STAFF REPORT

SUBJECT: FP-2023-0006
Stapleton No. 4

The Applicant proposes a Final Plat consisting of 53 building lots and 5 common lots on 7.47 acres of land in the R-15 zoning district.

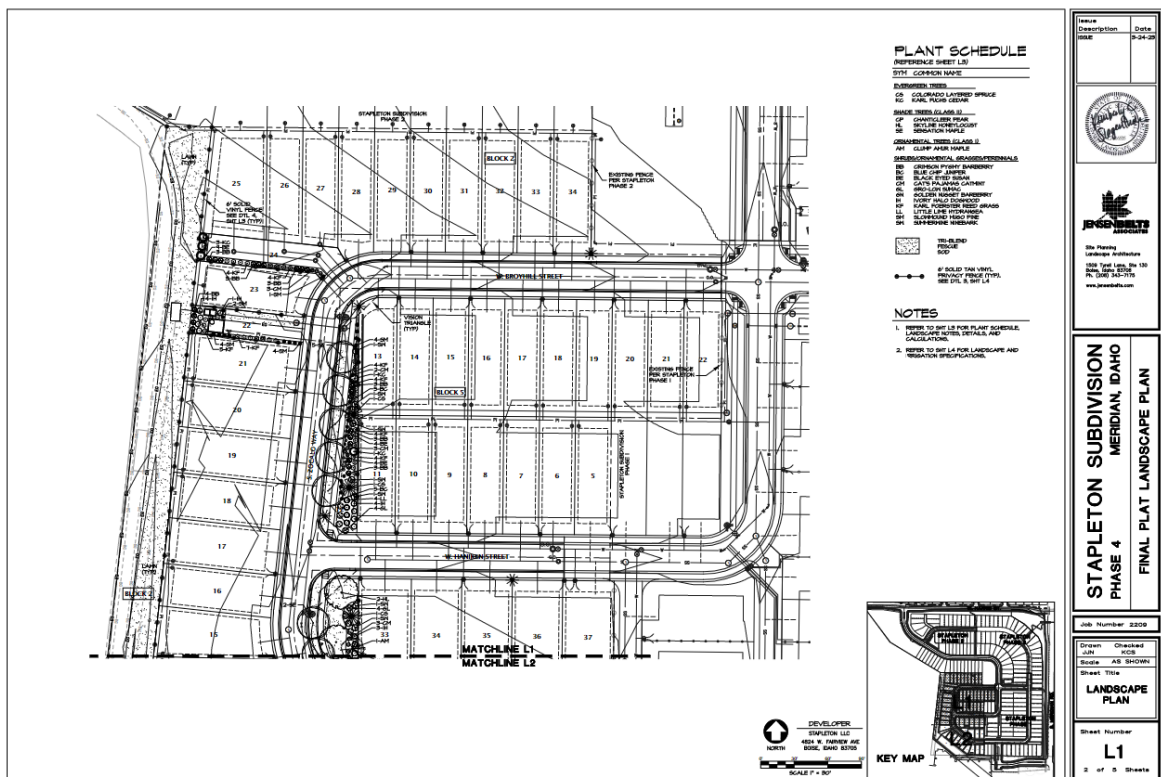
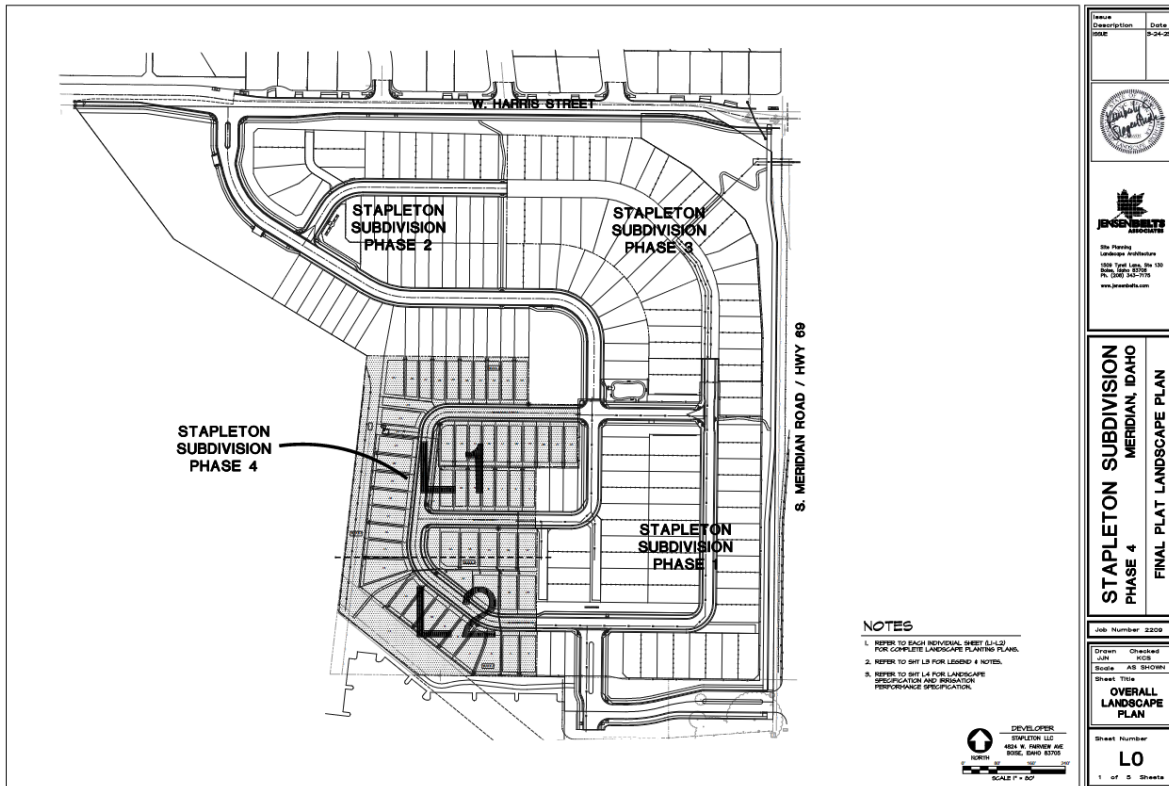
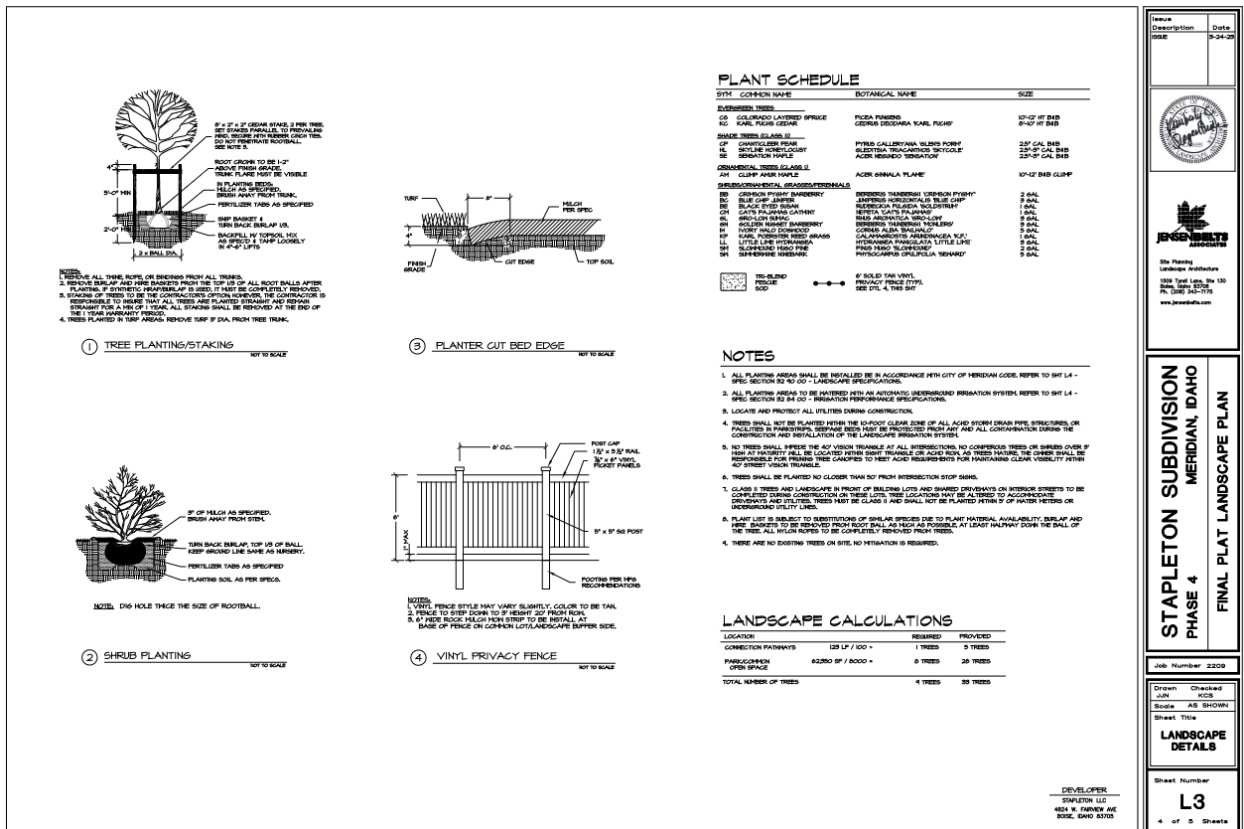
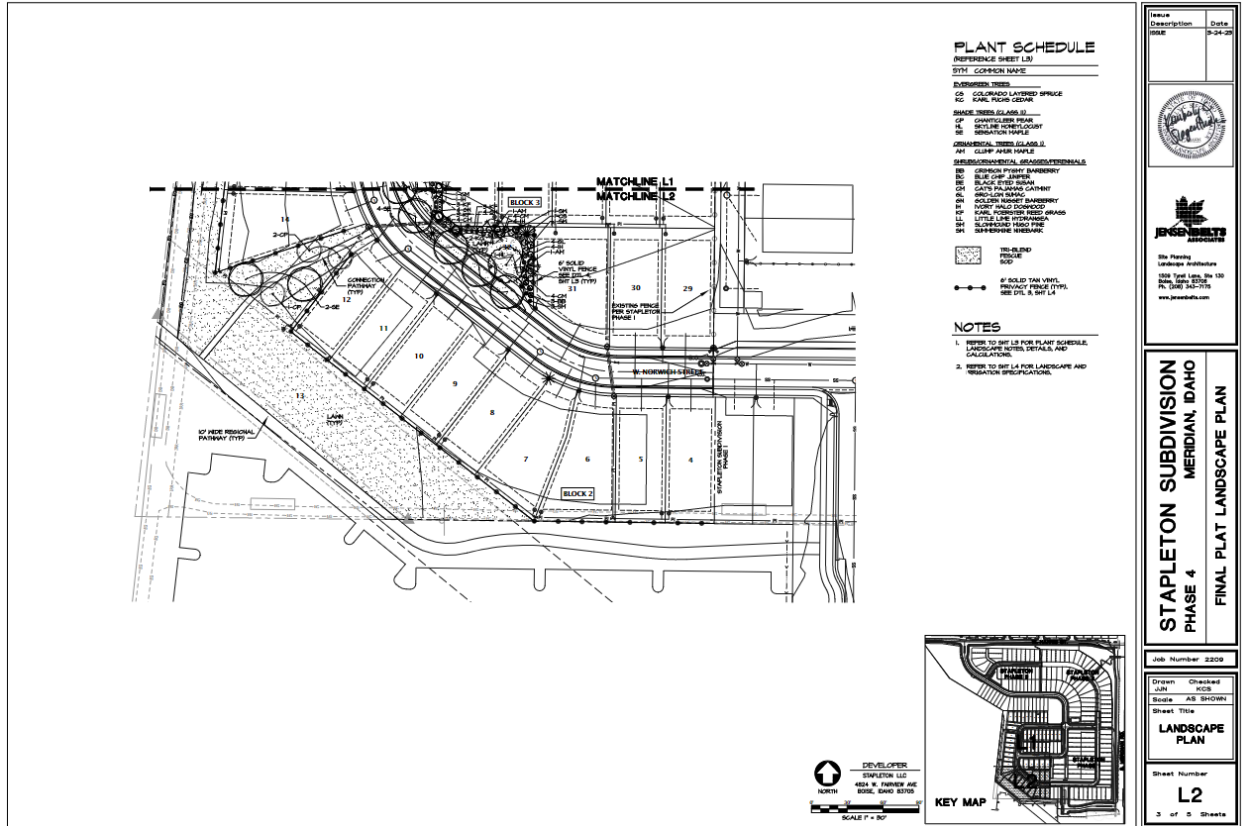
3. Prior to submittal for the City Engineer's signature, have the Certificate of Owners and the accompanying acknowledgement signed and notarized.
4. The final plat prepared by Fritz Brownell, Sawtooth Land Surveying, LLC, dated 3/2022, included in Section VII.B shall be revised as follows:

- a. Note #5: Revise the plat note to include the correct common lots and blocks on the plat.
 - b. Note #6: Include recorded instrument number for ACHD license agreement.

- c. Note #11: Include the Lots # and Blocks # that are servient to and contain the ACHD Storm Water Drainage System.
 - d. Note #12: Include the recorded instrument number for ACHD sidewalk easement.

- e. Note #14: Revise the to read "Lots 25-27, Block 2 will take access from Lot 24, Block 2."
5. The landscape plan prepared by Jensen Belts Associates, dated 2/25/22, shall be revised as follows:

C. Landscape Plan (dated: 3/24/23)

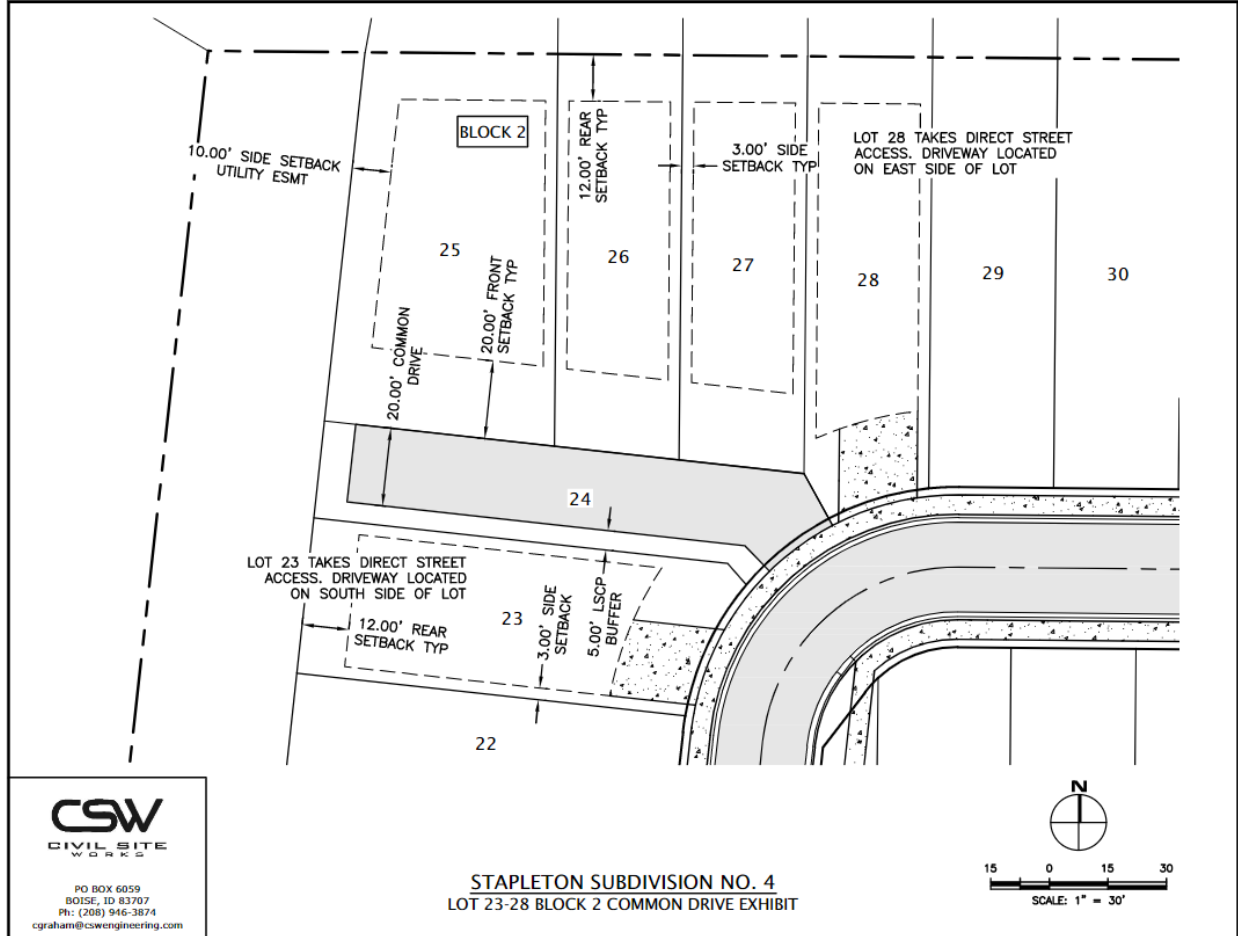
- a. Depict fencing adjacent to Lot 15, Block 3 in accord with the standards listed in UDC 11-3A-7A.7B.
 - b. Depict landscaping along both sides of the micro pathway on Lot 13, Block 2 adjacent to Lots 14 & 12 Block 2 with a mix of trees, shrubs, lawn, and/or another vegetative ground cover in accordance with UDC 11-3B-12C.1.2 prior to reaching the 75-foot wide easement.
